ADDENDUM NO.1

RFB - 927940-03

WRC Fire Alarm Phase 4

Project: 9279.40 BI#03 Fire Alarm Phase 4

1 FIRST FLOOR - FIRE ALARM RENOVATION PLAN
1/8" = 1'-0" 0 12'

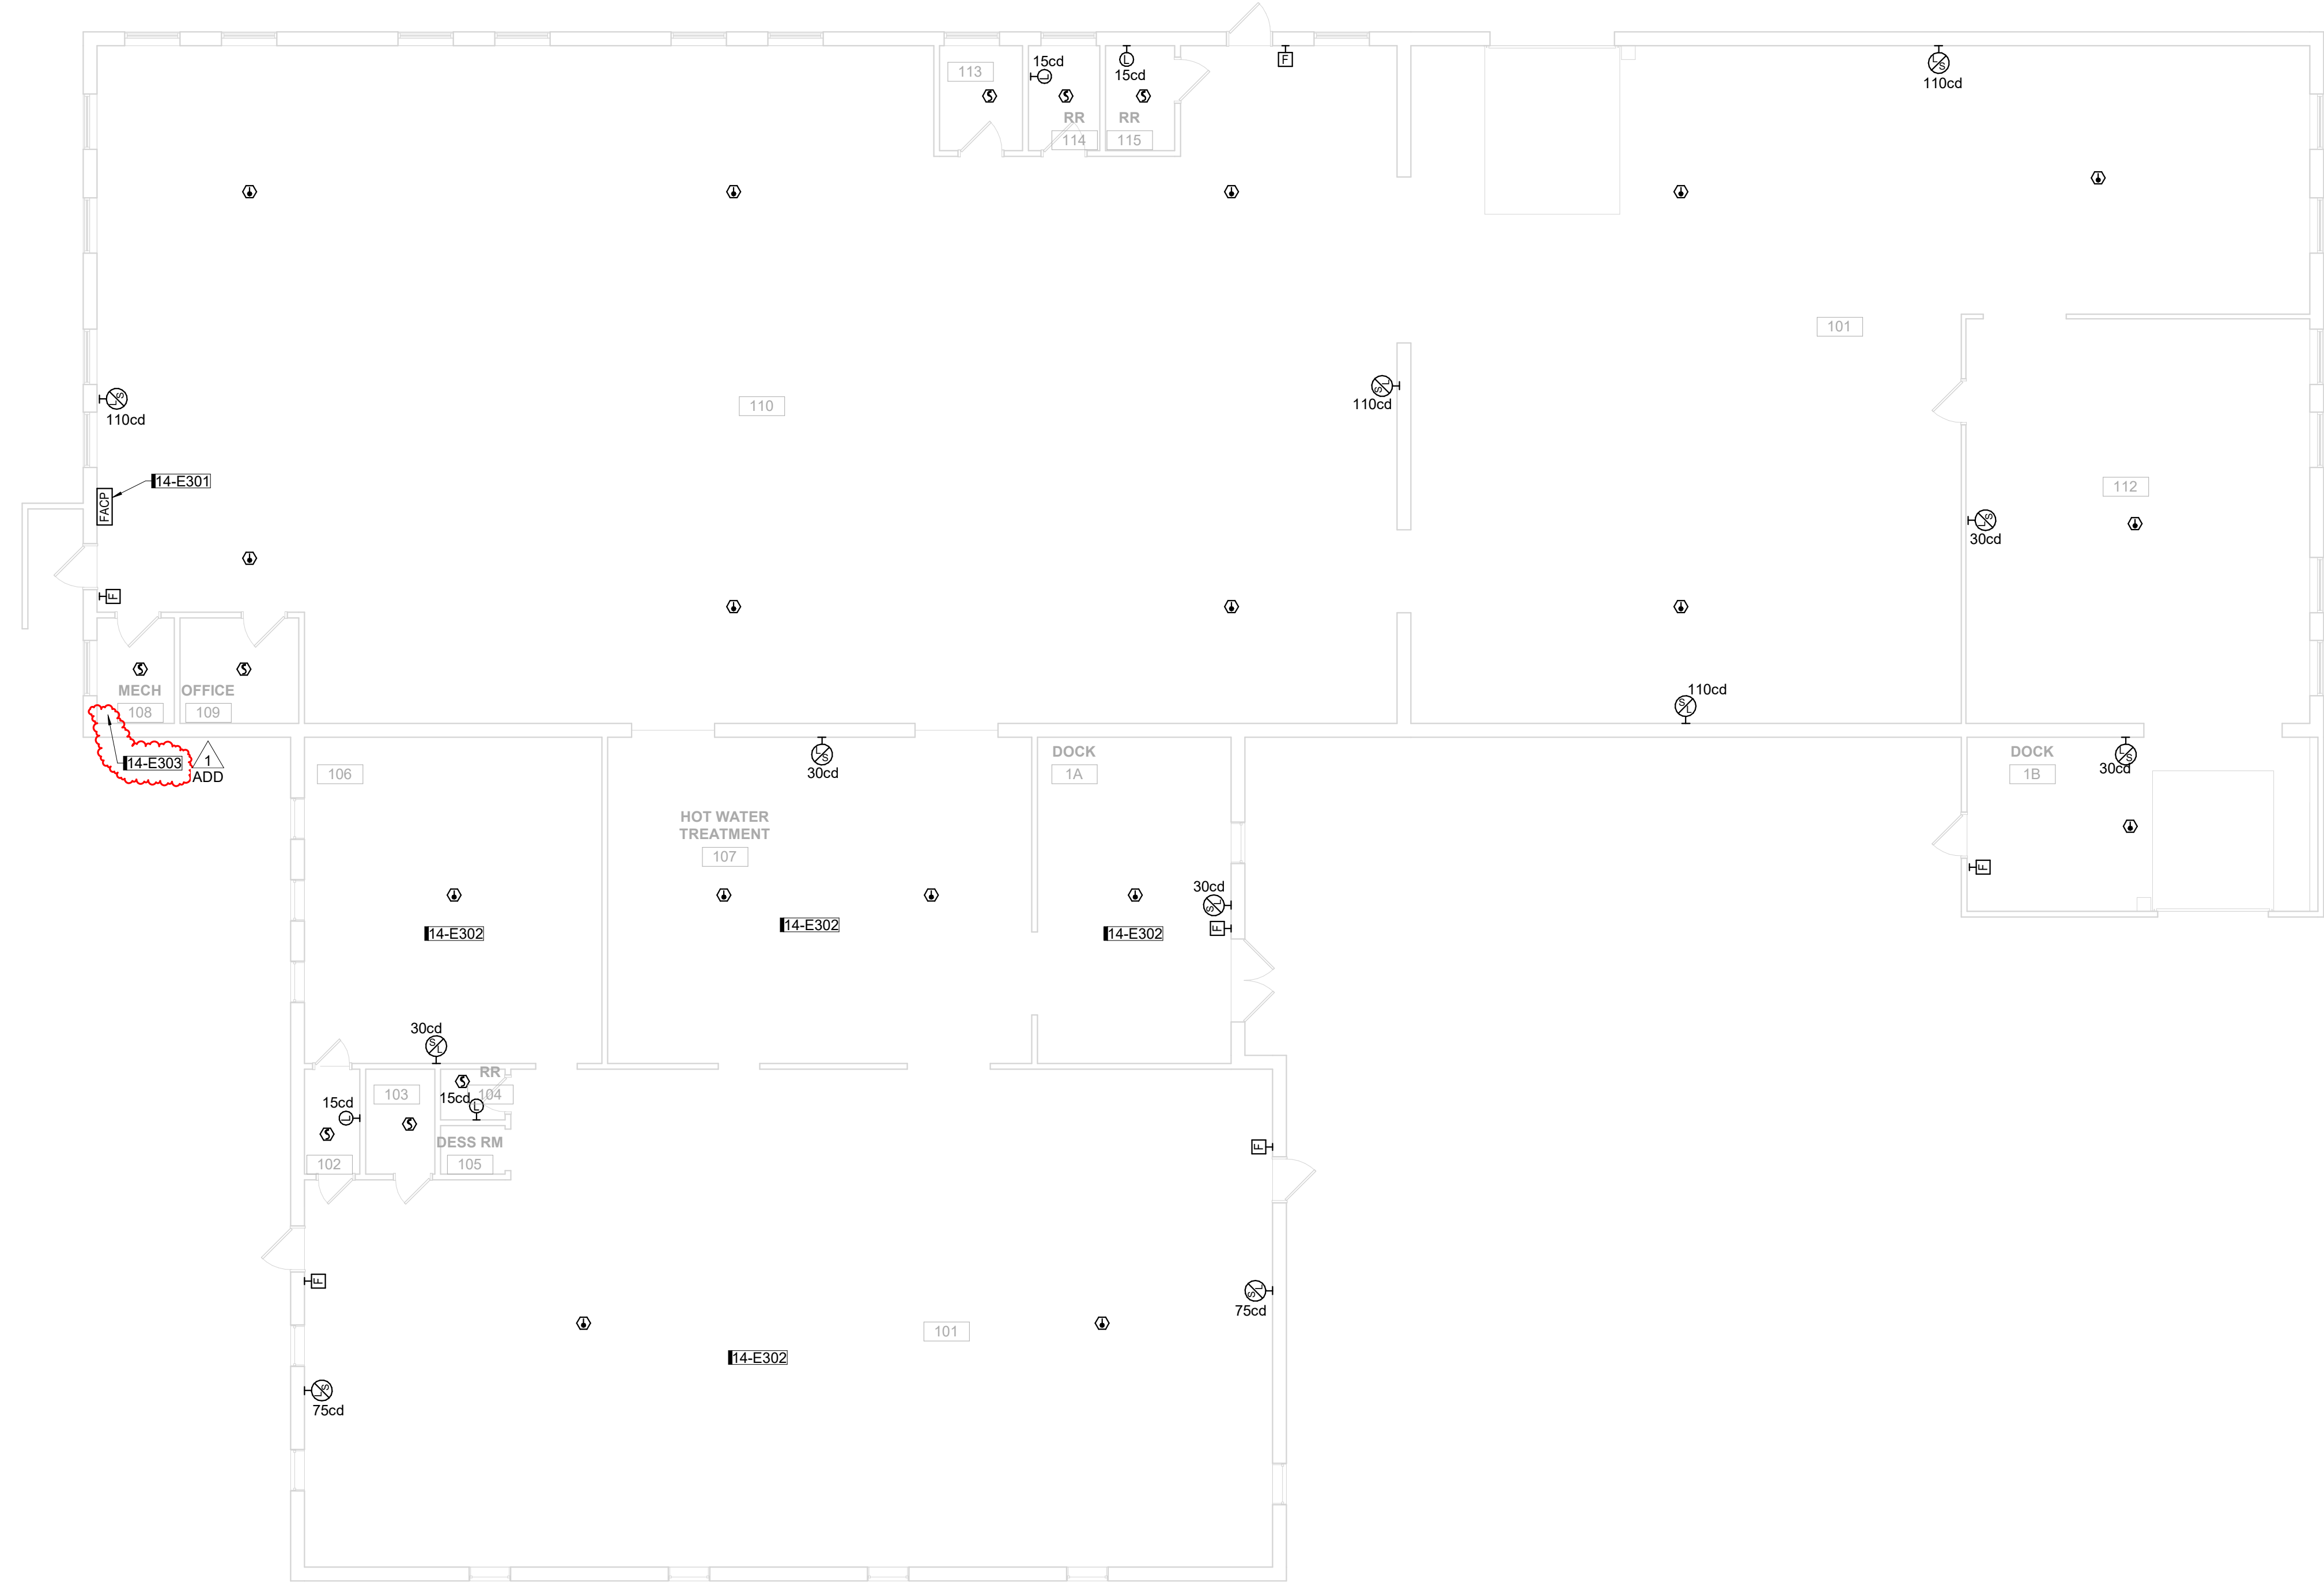
8. Where are the electrical panels located to get power to the new FACP's?
 - A) Existing circuit that feeds existing FACP's will be extended to feed the new FACP's

KEYNOTES	
KEY	NOTE
14-E301	CIRCUIT NEW FACP TO SAME CIRCUIT AS EXISTING FACP.
14-E302	ROOM HAS ACT CEILING.
14-E303	EXISTING FIBER ENTRANCE LOCATION. FURNISH AND INSTALL 6 STRAND OF SINGLE MODE FIBER FROM FIBER ENTRANCE TO FACP LOCATION. INSTALL FIBER IN 3/4" C. CONNECT FACP TO SINGLE MODE FIBER NETWORK.
